**Regional Sediment Management at the Mouth of the
Columbia River, Oregon and Washington**

**Independent Technical Review of the
Proposal for a
Washington Littoral Drift Restoration (Benson Beach)
Regional Sediment Management Demonstration**

Moffatt & Nichol

August 2006

Figure 3 – Typical Section of Benson Beach Placement Area

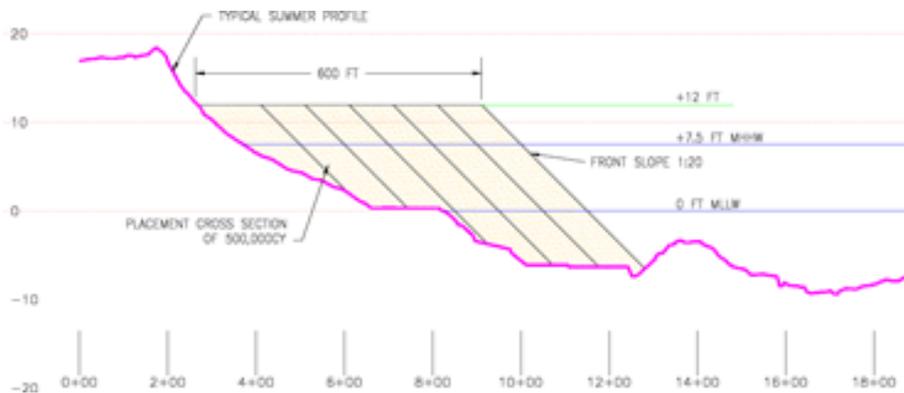
Finally, it is noted that PIE suggests that the proposed beach will be placed with a 20:1 slope extending from approximately +14 to -10 feet MLLW, see Figure 3. While it may be entirely possible to accomplish this construction template, it is quite likely that the material will be reworked and flattened by waves. It will be important to document the evolution of this fill and determine any effect it may have on adjacent shorelines.

Figure 6 – Erosion South of North Jetty Near Proposed Sump Site

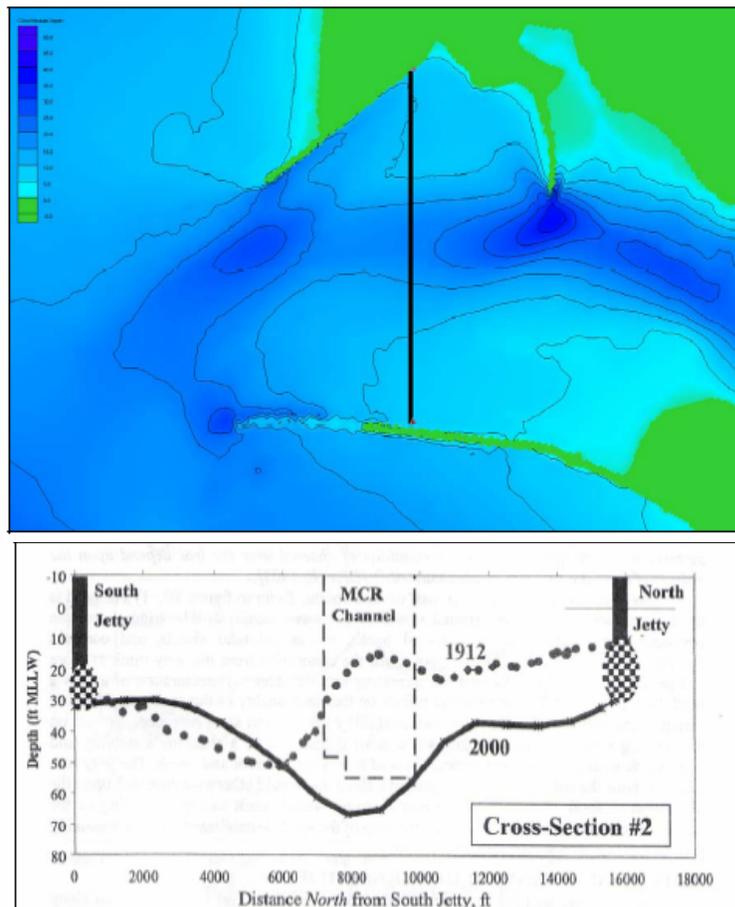
Bathymetric surveys taken just south of the North Jetty over time unequivocally show that the area has been subject to erosion over time. Figure 6 summarizes results presented by Moritz et al (2003)¹ and shows that the area in the vicinity of the proposed sump eroded

vertically on the order 20 feet between 1912 and 2000. Figure 7 illustrates bathymetric changes for two periods (1868-1958 and 1958-1998) and demonstrates the continued tendency for sediments to erode south of the North Jetty. Similarly, USACE officials indicate that that sediment placed at the North Jetty placement site erodes at a rate on the order of 300,000 cy/yr. Furthermore, tidal flow models (Figures 8 through 10) show that there is tendency for ebb flows to train against the south side of the North Jetty. The reader will note that there is not a similar tendency for flow training along the South Jetty. Figure 8 presents the PIE model results for peak ebb flow; similar results are presented in Figures 9 and 10 for USACE models. In fact, the purpose of Jetty A construction was to redirect ebb flows away from the south side of the North Jetty. Jetty A has indeed reduced, but has not eliminated, the tendency for flow training along the western reaches of the south side of the North Jetty. Furthermore, Moritz et al (2003) has documented the historic damage to the south side of the North Jetty owing to the scouring of sands. It should be noted that Reference 8 (PIE, June 2006), provided subsequent to draft report, includes an analysis of bathymetric surveys for the period August 1997 through July 2003. These data, which cover an eastern portion of the sump area, indicate as much as three feet of erosion in the central and southern portions of the sump area and areas of up to two feet of accretion along the northwest edge of the sump area adjacent to the NJ placement site. The latter accretional changes could be associated with placement of material at the NJ site. Nonetheless, these data support concerns that the sump is prone to long-term erosion. Accordingly, it can be concluded that the sump area is vulnerable to erosion. Great care must be exercised, therefore, in order to avoid any potential damage to the North Jetty. This fundamental has guided the ITR team as it has considered the efficacy and feasibility of the proposed sump construction.

Figure 11 – Flood Current Vectors are Similar With and Without the Sump

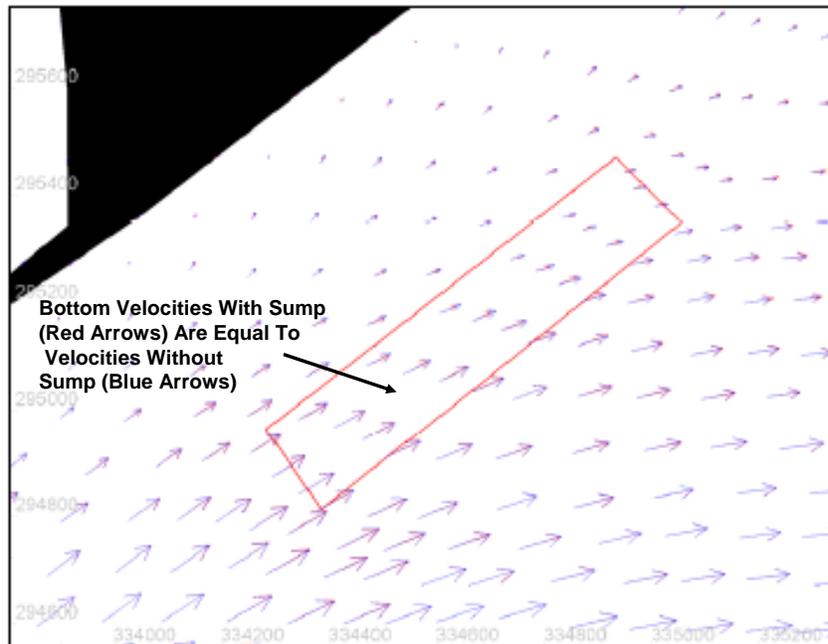
We agree that Item 1 (sump location 1,500 feet south of the jetty) and Item 2 (sump refilling) help to ameliorate the risk of the channel migrating towards the North Jetty. Questions remain, however. First, we note in Figure 11 that flood flow velocities at the bottom of the excavated sump are predicted to be same as those without the sump. This means that flood flow is attracted towards the sump area. If flood flow in the vicinity of the sump remained constant with dredging, then sump flood flow velocities would be

smaller owing to the increase in depth with sump excavation. For example, take the average depths before and after sump excavation as -34 feet and -46 feet MTL, respectively. Applying basic concepts of the flow continuity principle, one would expect the depth averaged velocities within the sump to be $34/46 = .74$ or 75% of the existing velocities. Ebb flow velocities are lower than existing as shown in Figure 12, but are not as low as 74% as shown in Figure 52 of PIE (2006). While this is not a major concern, the potential for the sump to attract flood flow could give rise to unanticipated morphological changes. As planned, the sump would be filled at the end of each summer dredging season. We are concerned, however, that there is risk that under unusual conditions, it might not be possible to fill the sump.

Figure 13 – Model of Potential Sediment Transport

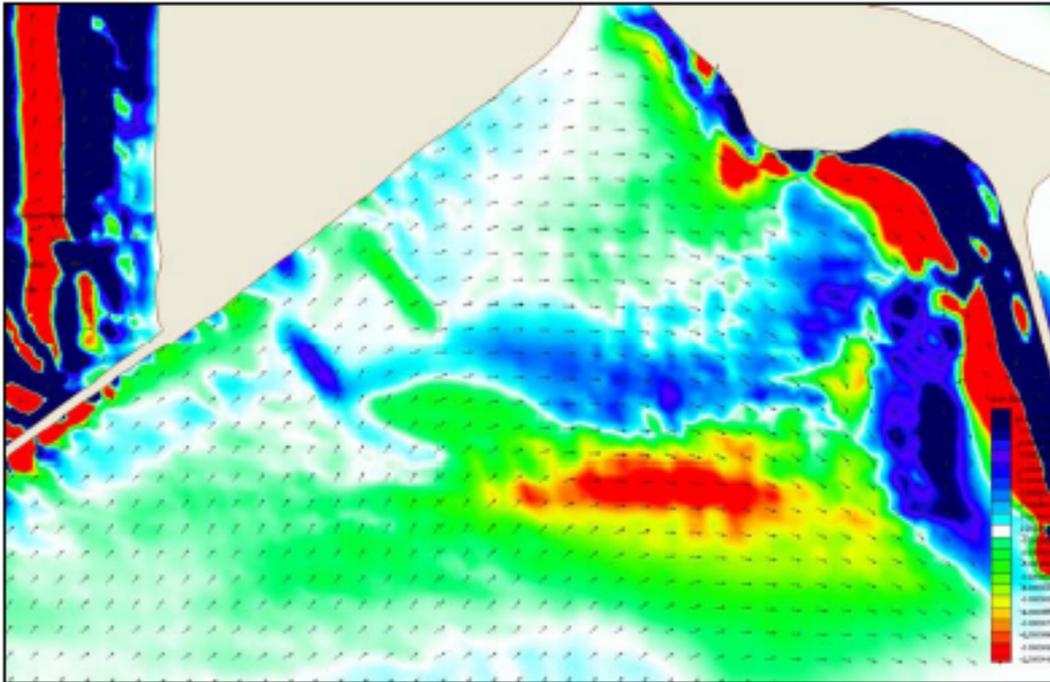
PIE have performed “potential” sediment transport analysis of the site location and have concluded that sediments will settle within the sump area, as illustrated in Figure 13. Both

PIE and M&N fully appreciate the complexities of, and vagaries associated with, sediment transport modeling and we commend PIE for their efforts. We note, however, that the numerical modeling performed to date has not been calibrated nor verified with actual bed changes in the vicinity of the sump. Accordingly, we do not dispute the trend identified by PIE for sediment to deposit in the sump. We do, on the other hand, conclude that the “potential” sediment transport modeling results have not been developed to the extent that they can be used to quantify short or long-term morphological changes in the vicinity of the sump. This is not meant as a criticism as further quantification is a difficult and time-consuming exercise.

Figure 14 – Wave Field Near North Jetty – Without Sump (PIE)

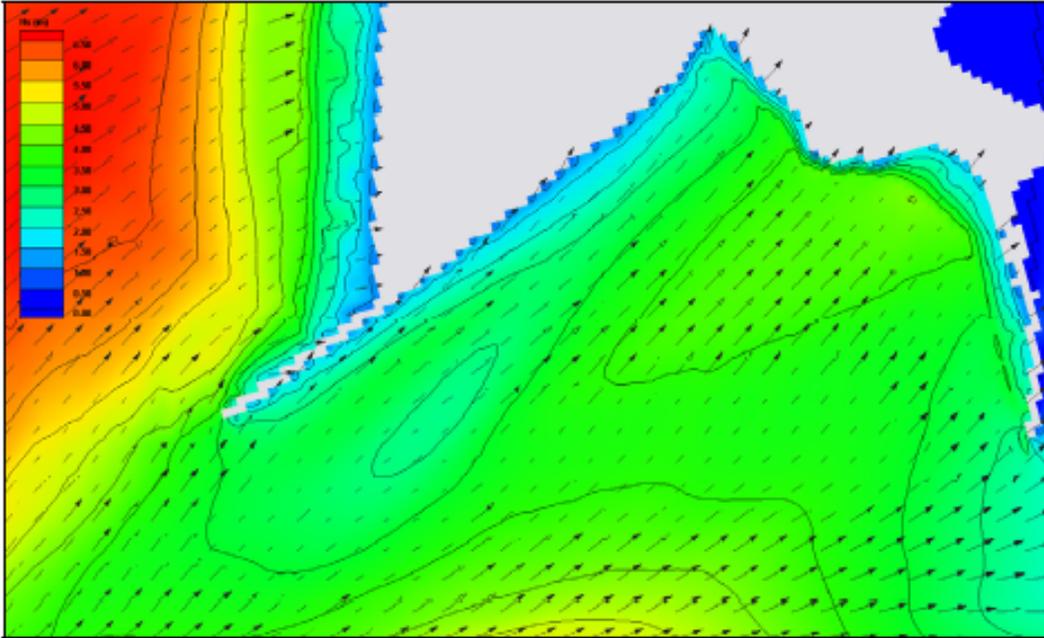
Figures 14 through 16 from PIE (Reference 4) summarize typical results for the increase in wave heights near the North Jetty and show that a 5 meter offshore wave increases approximately 0.5 m near the jetty. A similar plot developed by the USACE is shown in Figure 17. The differences in results for these two cases (i.e., Figure 15 and 17) stem from the differences in modeling technology and model setup. The fact that there are significant differences in the plots simply serves to point out that the uncertainties inherent in the numerical modeling of waves, especially within tidal inlets protected by jetties such as MCR. Again, we do not criticize any one result but weigh the information available to us and surmise that estimates of wave climate at sump and jetty are approximations and would benefit significantly from additional field measurements directly at the sump location coupled with additional modeling.

As previously mentioned, Figure 21 shows wave measurements taken offshore and at a station south of the proposed sump. Whereas the PIE model results for this wave condition (see Figure 14) suggest that the nearshore waves would be lower than offshore waves, the measurements show that the nearshore waves are approximately the same height as the offshore wave. Accordingly and as stated above, we are concerned that the wave models require more calibration against additional wave measurements in order to assure that the models accurately reproduce nearshore waves for a full range of offshore wave conditions. Such activities could continue while the suggested HDPAs are carried out.

Figure 21 – 2005 Wave Measurements 29 August, 2005 (USACE)

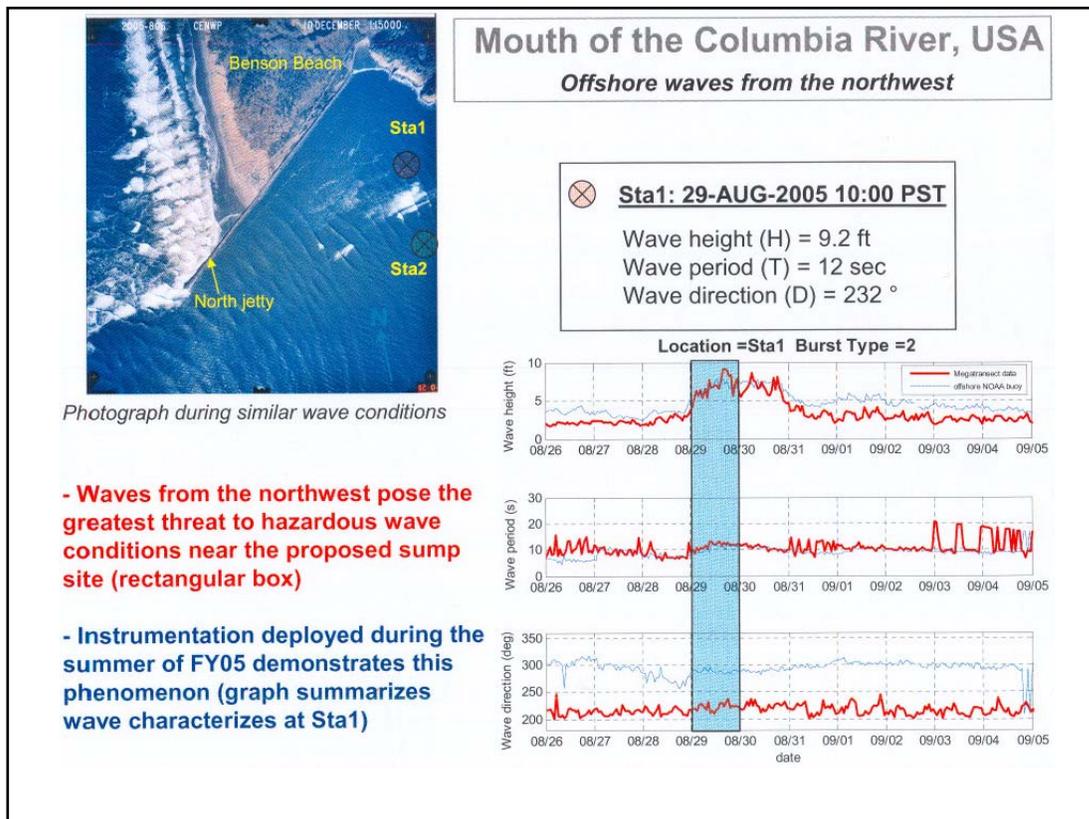
Figure 21 presents example wave measurements obtained by the USACE for August 29, 2005. This plot shows: (1) that the offshore and nearshore wave heights are the same; and (2) that problematic wave heights can build quickly in a matter of 6 hours or so. Although detailed comparisons are not available, the first point is inconsistent with Figure 14 which shows (for reasonably comparable wave direction and period) that waves in the vicinity of the recording station are less than the offshore wave height. The second point is relevant to dredging operations inasmuch as it suggests that rapid deterioration of local wave conditions may not allow sufficient time for a dredge to exit the sump area prior to experiencing excessive wave heights for safe working.

Figure 26 – 2002 Dredge Bid Analysis

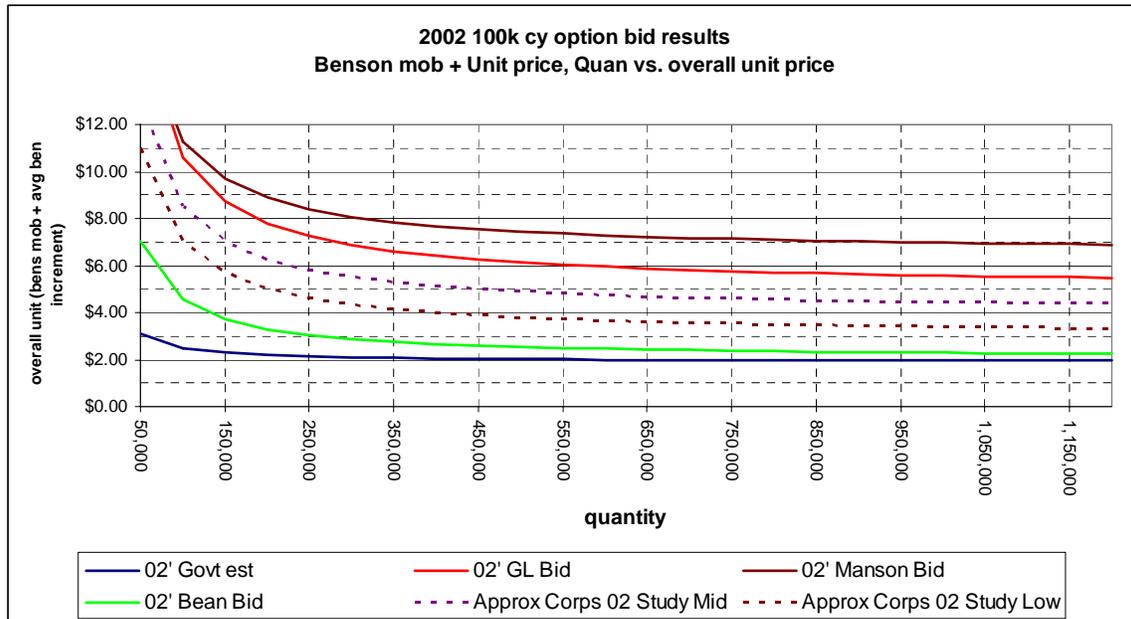
- The graph in Figure 26 presents a similar analysis as in Reference 1 (USACE 2002) but shows all bids. The Great Lakes Dredge and Dock (GL) line is the one used as the high line with an average and low offset, but not widely enough to cover the other bids received. Approximations of the USACE mid and low projections are shown dashed. Given the bandwidth, this analysis is not conclusive. By the USACE numbers, the incremental beach fill cost for the expected quantity is

anywhere from approximately \$3.5 to \$6.00. The as-bid variation was wider from \$2 to \$7 per cy, demonstrating how inconclusive basing a cost estimate on a small quantity optional bid can be.
